**REZONING,
PLANNED UNIT DEVELOPMENT
SIDEWALK WAIVER &
SUBDIVISION STAFF REPORT**

Date: October 18, 2007

<u>APPLICANT NAME</u>	Orchard Baptist Church
<u>DEVELOPMENT NAME</u>	Orchard Baptist Church
<u>SUBDIVISION NAME</u>	Orchard Baptist Church Subdivision
<u>LOCATION</u>	6960 Overlook Road (Southeast corner of Overlook Road and Howells Ferry Road).
<u>CITY COUNCIL DISTRICT</u>	Council District 7
<u>AREA OF PROPERTY</u>	11 Lot / 7.0± Acres
<u>PRESENT ZONING</u>	R-1, Single-Family Residential & B-2, Neighborhood Business
<u>PROPOSED ZONING</u>	B-1, Buffer Business District
<u>CONTEMPLATED USE</u>	Rezoning from R-1, Single-Family Residential, and B-2, Neighborhood Business, to B-1, Buffer Business, to eliminate split zoning in a proposed one-lot subdivision for a church. Planned Unit Development Approval to allow four buildings on a single building site, and Subdivision approval to create one legal lot of record.
<u>REASON FOR REZONING</u>	The reason for rezoning provided by the applicant reads as follows: to eliminate split zoning of a proposed one-lot subdivision

SITE PLAN

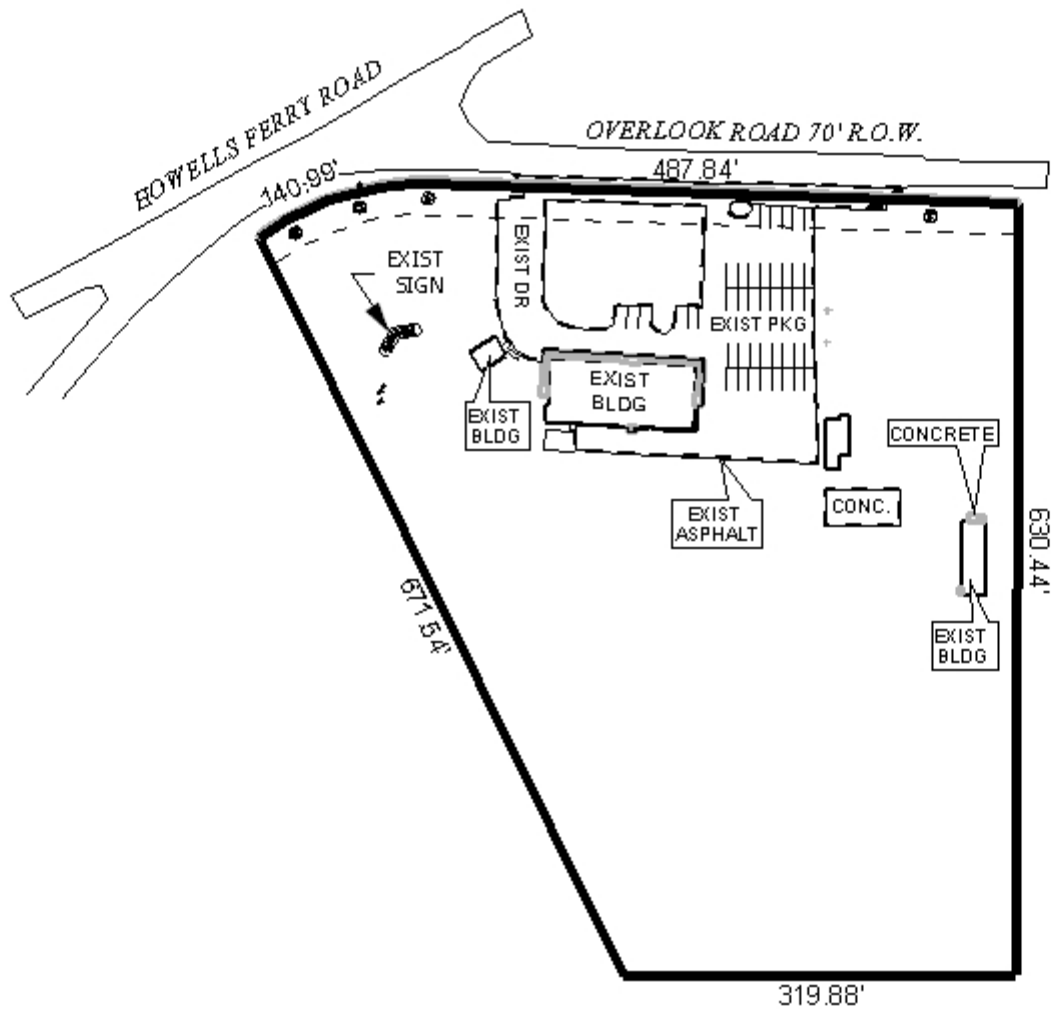
There are several issues with the Rezoning and Planned Unit Development applications as submitted. First and foremost, the site plans submitted do not include any dimensions of improvements. This lack of dimensions makes it virtually impossible to review; and, since these applications are site plan specific, virtually impossible to ensure compliance with the approved plans.

Also, there appear to be some discrepancies between parcel dimensions illustrated on the proposed plat and those of common parcel lines with Overlook Station Subdivision. These discrepancies should be corrected.

Another issue is that the required narrative describing the proposal is incomplete and does not provide adequate information. While there is information about the attendance and number of pews, neither of these provide seating capacity of the sanctuary which determines parking requirements. The narrative includes a statement about members parking across the street; however that property was not included in the application, nor is the uses of the various buildings clear.

In essence, the plans submitted are incomplete and cannot at this time be reviewed.

Planned Unit Development: Based upon the preceding, this application is recommended for HOLDOVER until the November 15 meeting to allow the applicant to revise the plan to provide All dimensions for plan review, include all properties associate with the church and used for church functions (parking, services, classrooms, etc)
